# ERRATA
P112 Single Board Computer Kit

Serial connector wired straight through (solder side view).

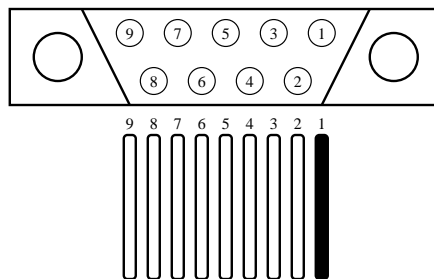
The serial port pigtails supplied in this kit are not wired correctly for use with the P112 single board computer. Unfortunately, I could not return these pigtails to where I bought them.

The following diagram generates the same pinout as a 9-pin serial port found on a typical x86 PC.

Serial connector with null modem crossovers (solder side view).

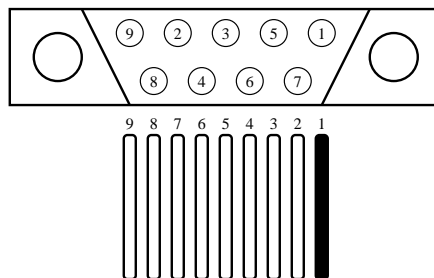
If you need to use a null modem adapter to connect to a serial terminal, use this diagram to eliminate the need for an external adapter:

The above diagram will also allow you to connect the P112 to an x86-style serial port with a 9-pin to 9-pin straight-through cable.
